**Westfield Montgomery Mall- Preliminary Plan Amendment 12005018B**

Staff Report Date: 8/22/14

**Westfield Montgomery Mall (Lakeview Parcel P)  
Democracy Boulevard, Bethesda:  
Preliminary Plan Amendment 12005018B**

A request to modify Condition No. 11(a) of Preliminary Plan 120050180, Westfield Montgomery Mall; 60.02 acres; C-2 Zone; Potomac Subregion Master Plan.

Figure 2 Intersection Capacity Analyses and Comparison

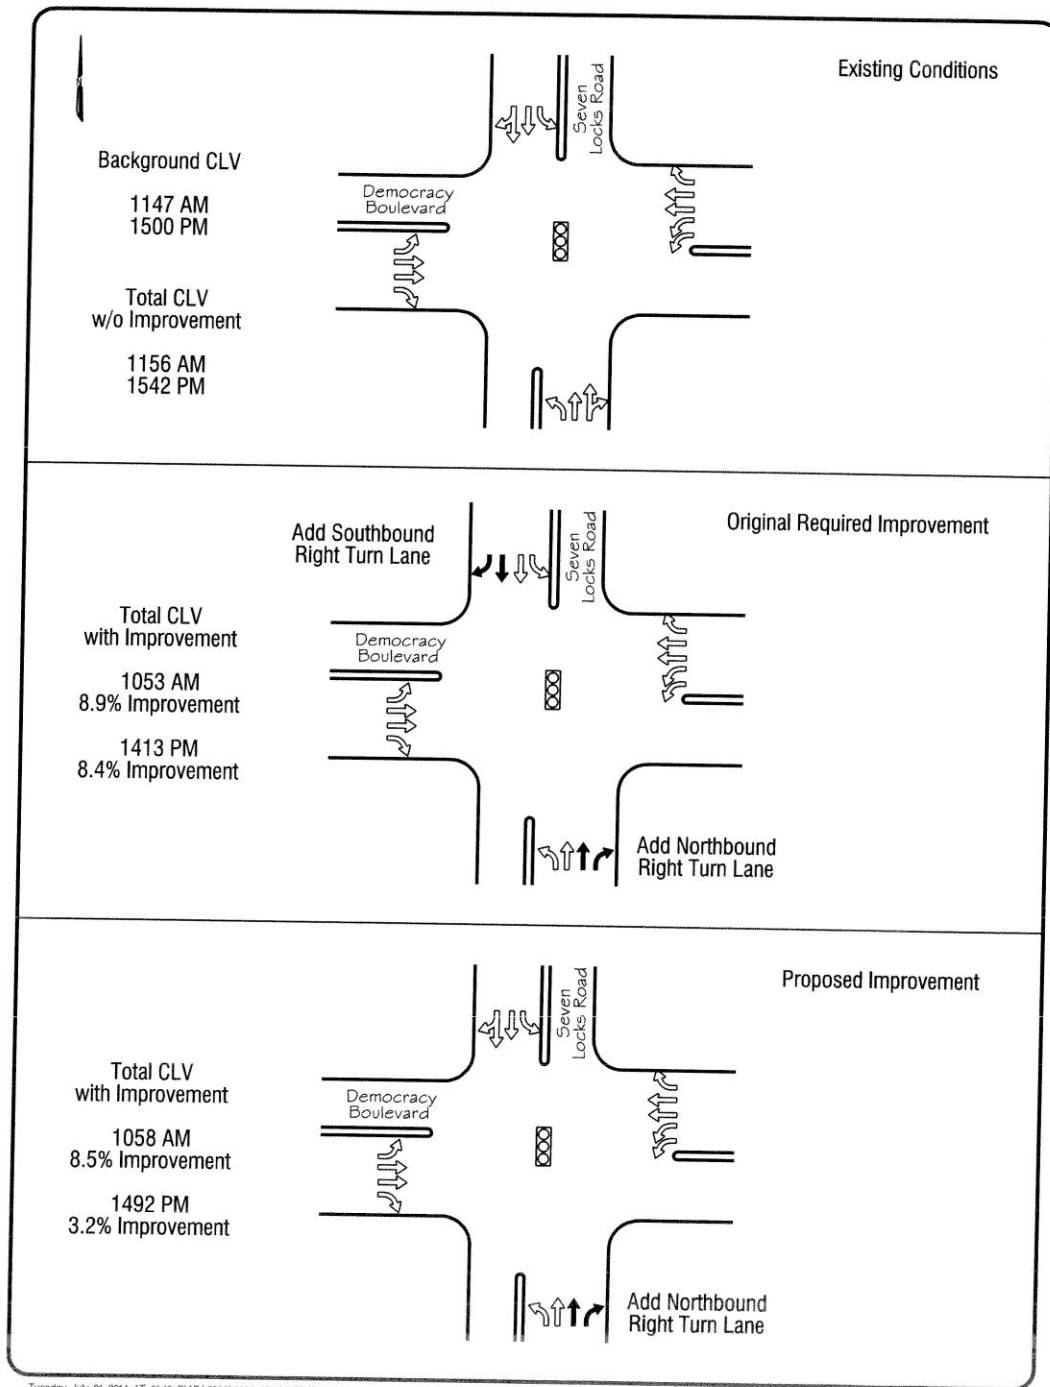
The Applicant conducted Intersection Capacity Analyses for the intersection for existing, background, and total traffic conditions as depicted in the 2004 approved traffic study (See Figure 2 and Attachment 4). The total traffic conditions were evaluated assuming the northbound and southbound right turn lanes, and also for the construction of just the northbound right turn lane. Figure 2 illustrates that the provision of both lanes resulted in acceptable levels of service during the peak periods. It also indicates that the provision of only the northbound right turn lane would have been sufficient to mitigate the impact of the subject property and would have complied with the LATR Guidelines.

At the request of staff, the Applicant conducted new turning counts at the intersection on November 7 and 19, 2013. Based on the updated intersection counts, the Applicant conducted critical lane volume (CLV) intersection capacity analysis of total traffic conditions, including background traffic and the traffic projected to be generated by the Westfield Montgomery Mall. The results of these analyses indicate that the intersection is still projected to operate at a satisfactory level of service during both the morning and evening peak periods, even with the elimination of the southbound right turn lane (Figure

2). The traffic volumes at the intersection today are less than the 2004 counts. With existing traffic conditions, the addition of the northbound right turn alone will result in a CLV below the 2005 CLV standard of 1,475 for this intersection, as well as today's standard of 1,450.

Figure 4 Existing and Proposed Design – South Side of Intersection (Northbound Lanes)

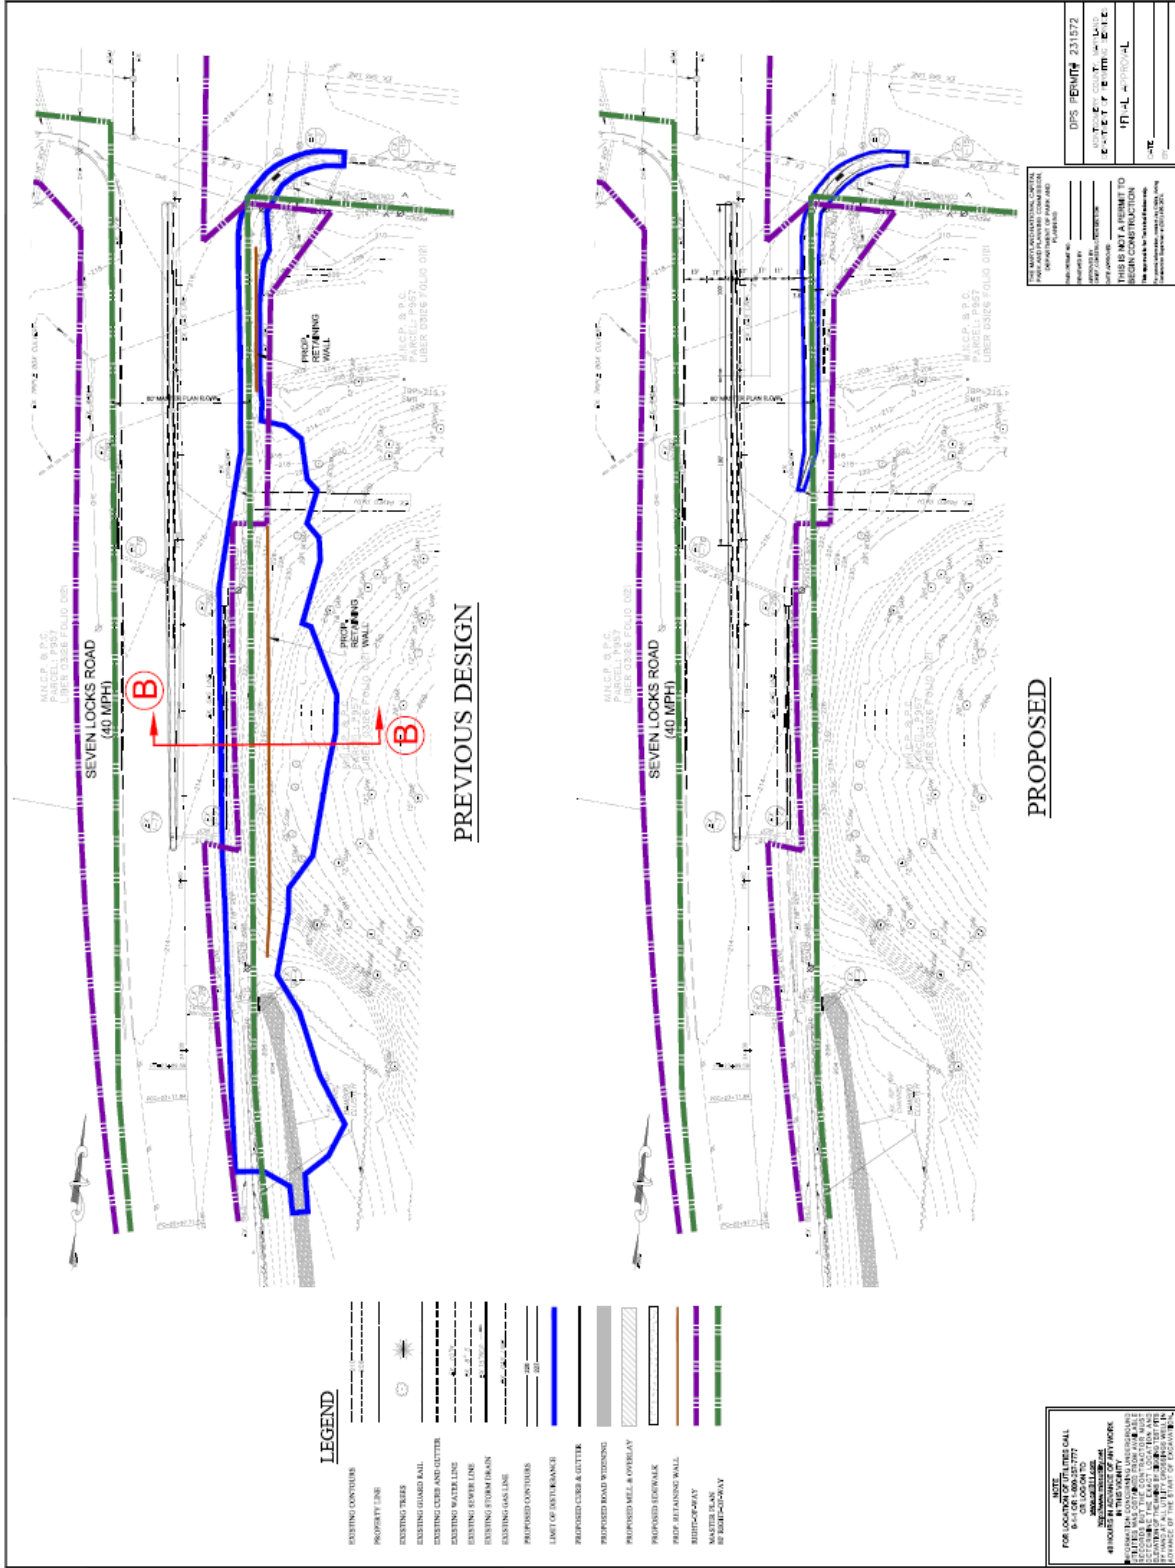
The Applicant has prepared a Concept Plan for adding the northbound right-turn lane. The concept provides an 11 foot northbound left-turn lane, two 11 feet through lanes, and a 13 foot right-turn lane.

Figure 3 depicts the existing and proposed configurations; Figure 4 depicts the existing and proposed design for the south side; Figure 5 similarly for the north side; Figure 6 depicts the alternative cross sections; Figure 7 provides more detail for the north bound proposed improvements; and Figure 8 graphically illustrates the considerable reduction in the limits of disturbance.

Figure 5 Existing and Proposed Design North side of Intersection (Southbound Lanes)

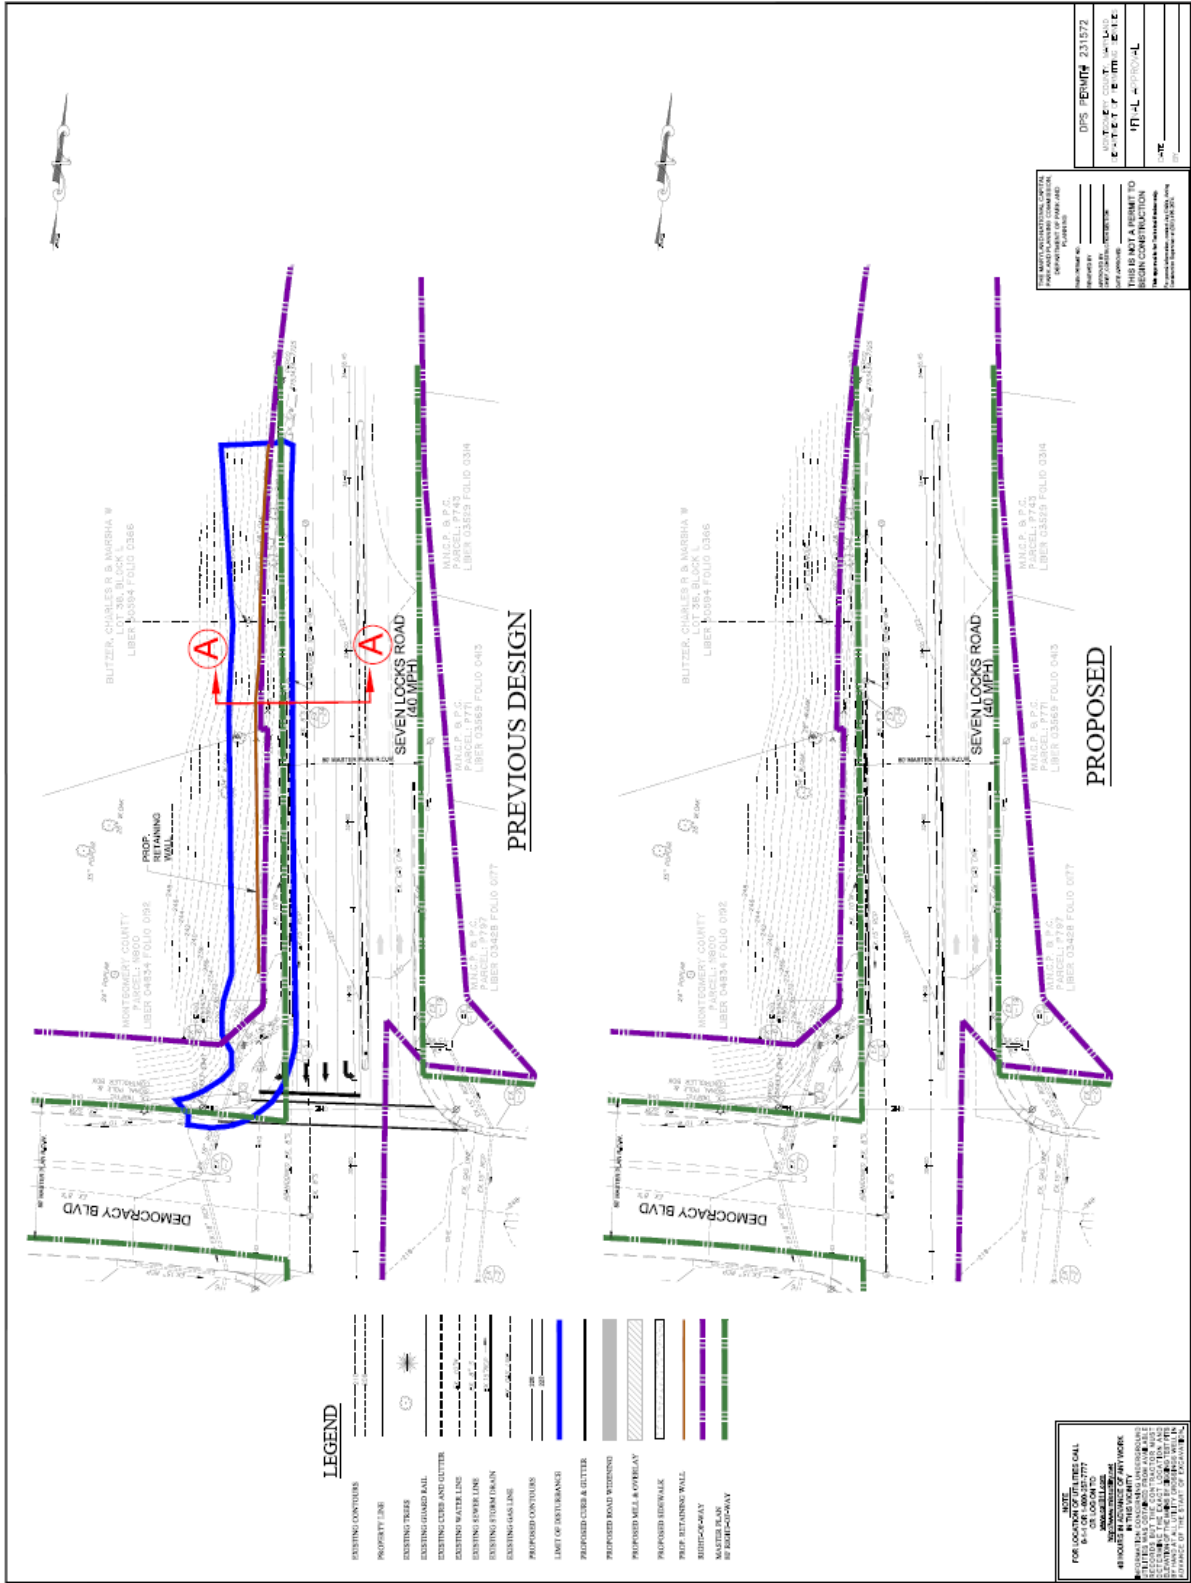
1. Elimination of the southbound right turn lane requirement which removes the need for taking 2,285 square feet of Parkland, environmentally damaging grading, removal of 4 large trees of 26" diameter or greater and the construction of a visually dominating retaining wall over 300 feet long and 9 feet high at its highest point.
2. Reconfiguration of the northbound lanes in a manner acceptable to MCDOT which will result in considerably less environmental damage, removing the need for a retaining wall 250 feet long and up to 16 feet high, and a storm water management facility of almost 5,300 square feet within the existing stream valley park.

DESIGNED BY: [ ]  
 DRAWN BY: [ ]  
 CHECKED BY: [ ]  
 DATE: 03/20/14  
 TITLE: CONCEPT PLAN

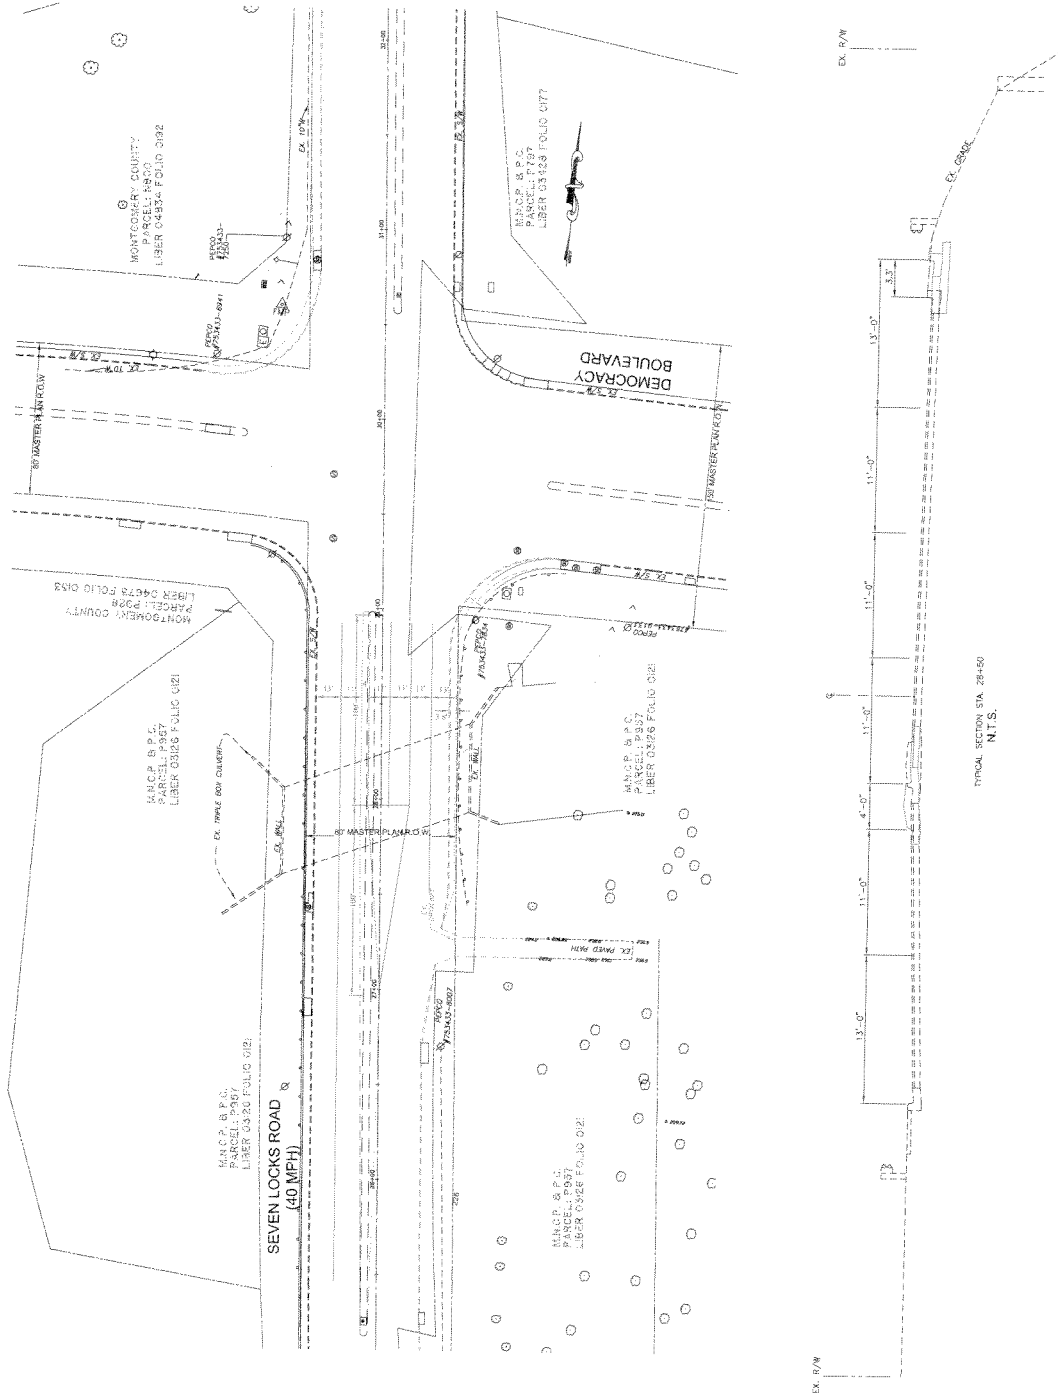
We have completed our review of the June 13, 2014 edition of the applicant's concept plan to implement a northbound right turn lane on Democracy Boulevard at its intersection with Seven Locks Road. In our May 15, 2014 letter to the applicant's attorney, Ms. Elsie L. Reid, we indicated that "Intuitively, we support approval of the proposed modification and the Limited Preliminary Plan Amendment." In subsequent discussions with the applicant, we agreed with the base geometric layout of the applicant's plan. We have been requested to provide you a letter which formally confirms MCDOT's position on the conceptual intersection improvement plan.

- We support Planning Board approval to delete the previously required southbound right turn lane on Seven Locks Road at this intersection.
- Although there does not currently exist a sidewalk on the east side of Seven Locks Road, there is evidence of a worn path approaching this intersection. MCDOT defers the specifics of the plan (with respect to the need for formal or informal accommodation of pedestrians) to the Department of Permitting Services at the permit stage, including design treatment of the guardrail at the culvert headwall.
- Milling and overlaying of the existing pavement on Seven Locks Road may be required by the Department of Permitting Services at the permit stage.

We approve the proposed concept plan subject to the following comments.
